Architect's Supplemental Instructions

Architect's ASI No: 013

Project:
Webster University
Interdisciplinary Science
Building

Description: ASI – 013 (RFI – 110, RFI-153, RFI-161 & RFI-178)

P0101.B

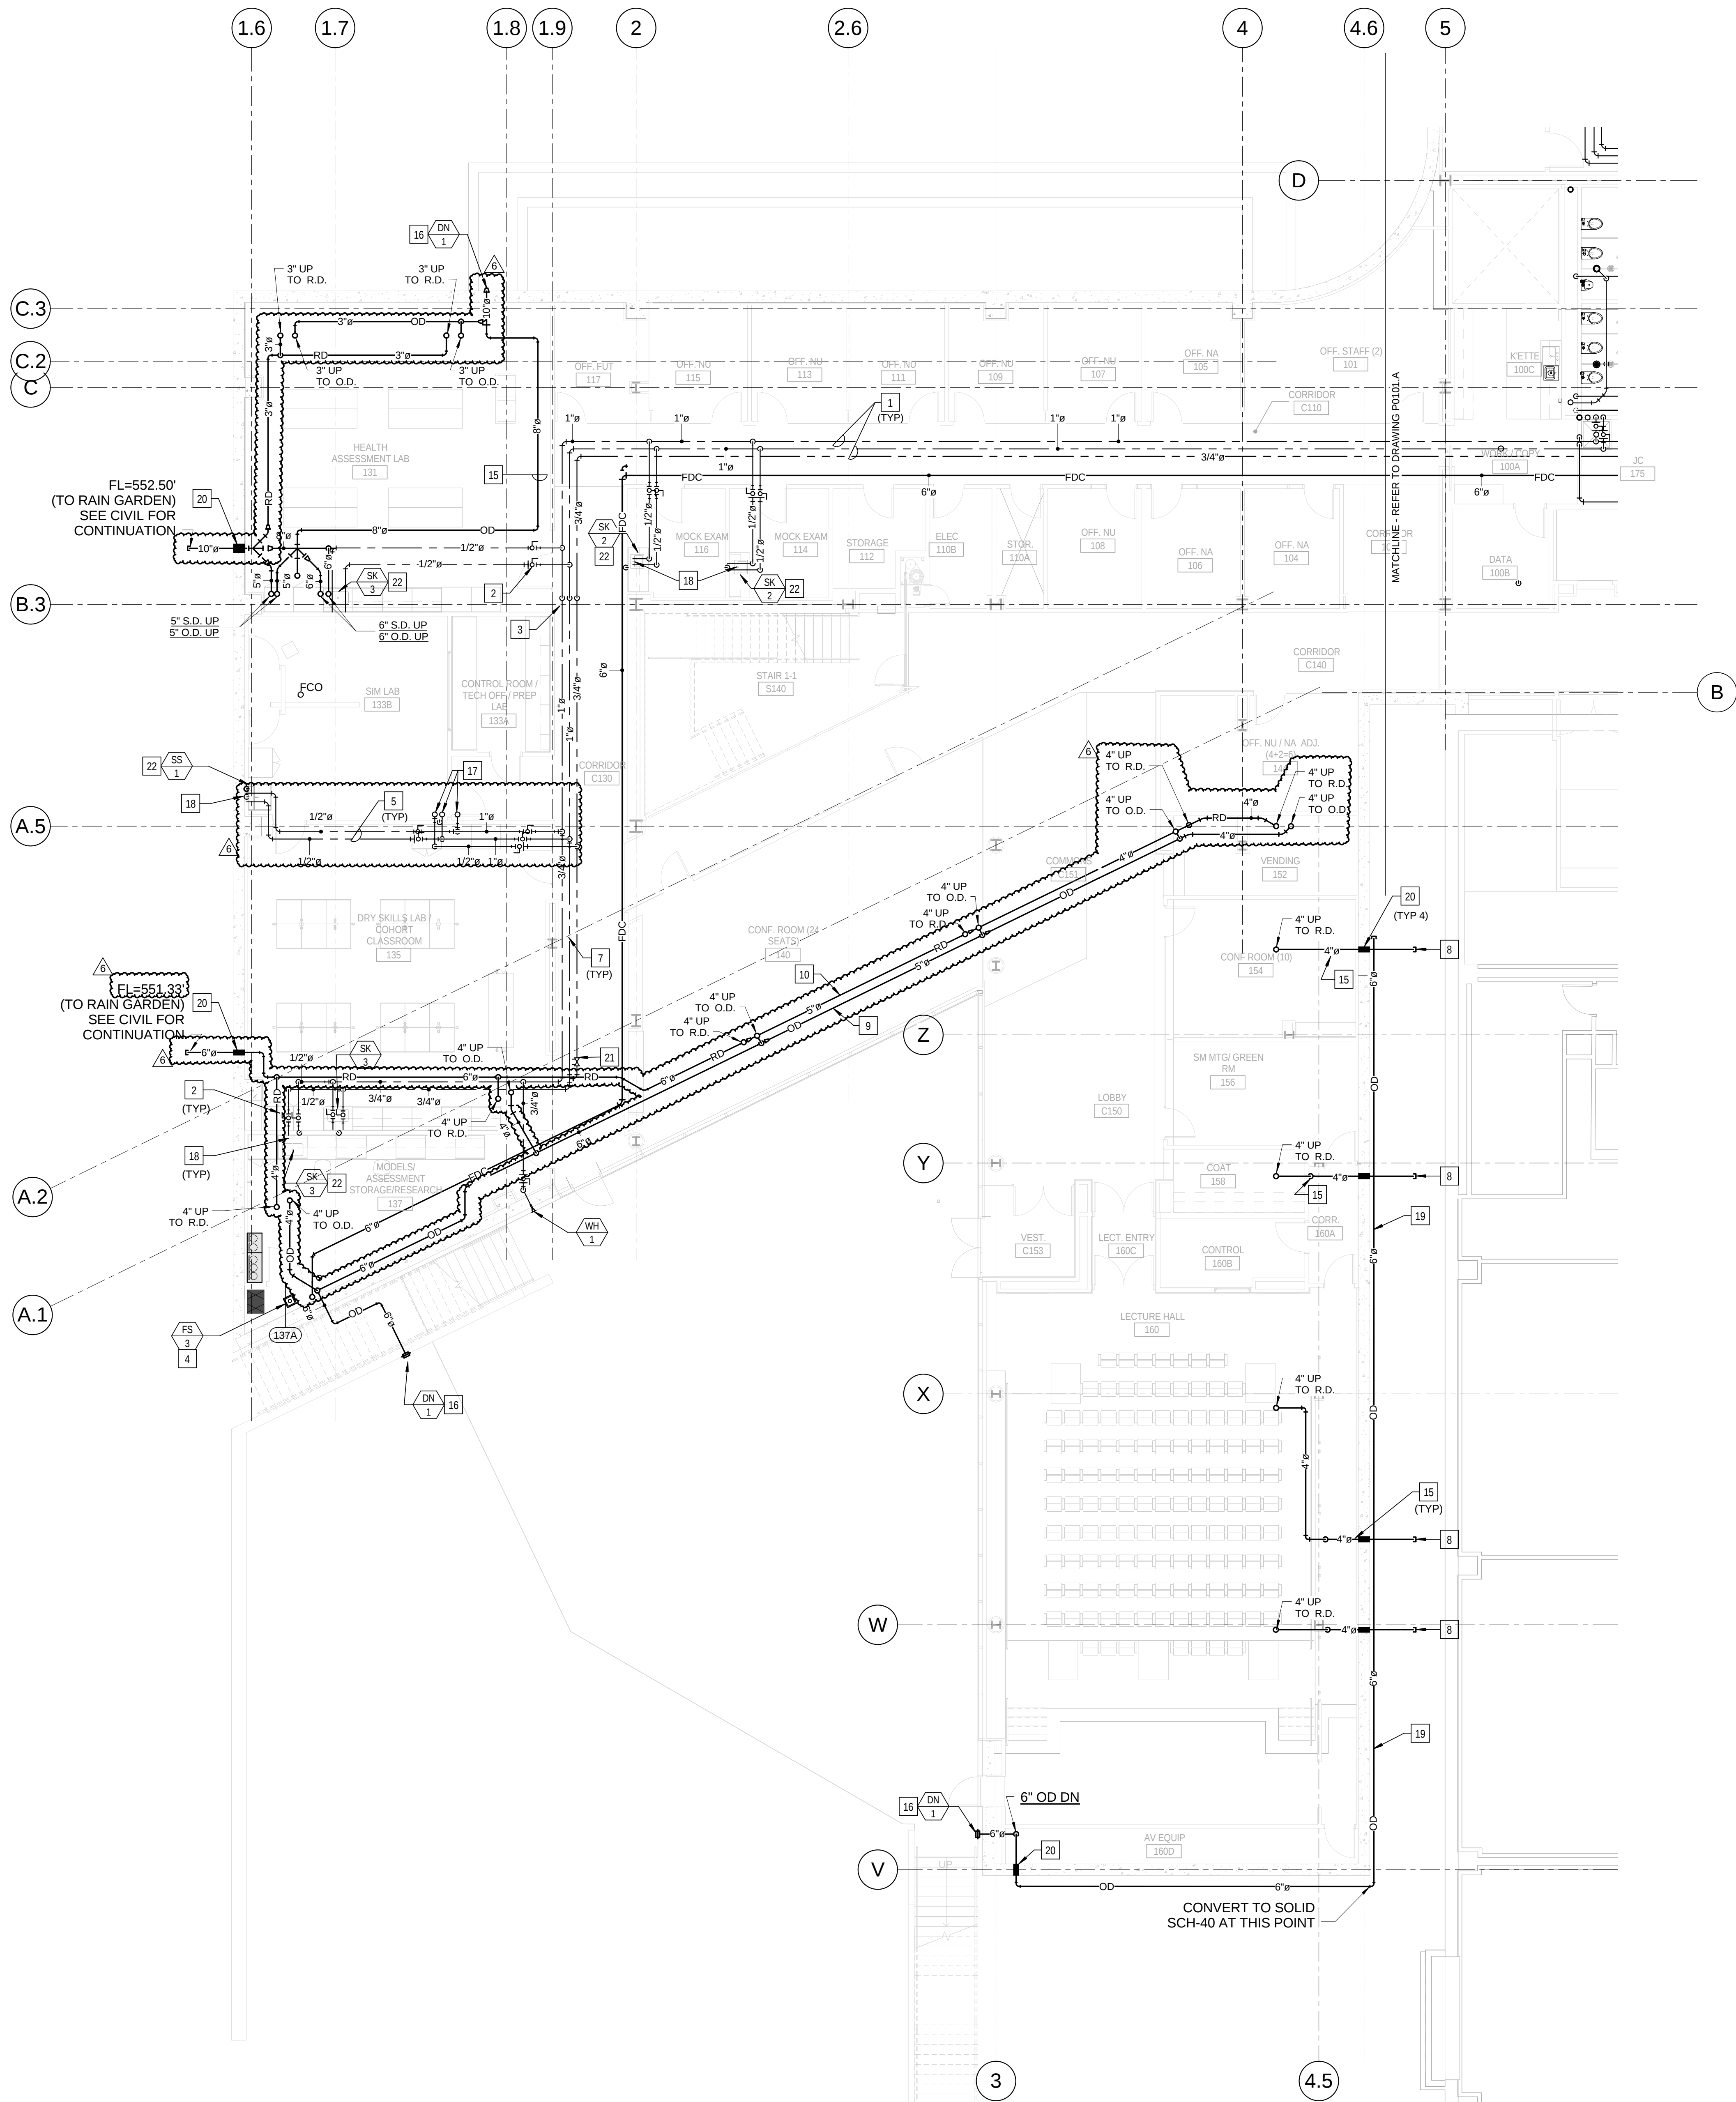
RFI-110: Add 1 Roof Drain (RD) and 1 Overflow Drain (OD) as located on architectural drawing A0423, Level 02, Area B at column line A.5 between 4 and 4.5. These drains had been inadvertently left out. Some modification to the alignments and downstream pipe sizes has been made to incorporate these changes. Refer to drawing P0101.B for associated changes.

RFI-153: 4 inch discharge roof drain leader has been change to a 6 inch discharge to accommodate the upstream flows. Refer to drawing P0101.B for this change.

RFI-161: Add 2 Roof Drains (RD) and 2 Overflow Drains (OD) as located on architectural drawing A0423, detail 4. These drains had been inadvertently left out. Some modification to the alignments and downstream pipe sizes has been made to incorporate these changes. Refer to drawing P0101.B for associated changes.

RFI-178: Water and vent piping to be reconfigured per attached drawing P0101.B and P0111.B. Provide safety pan below piping as indicated on plans with 1-inch drain pipe to floor sink located in Room 137A on Level 01, Area B.
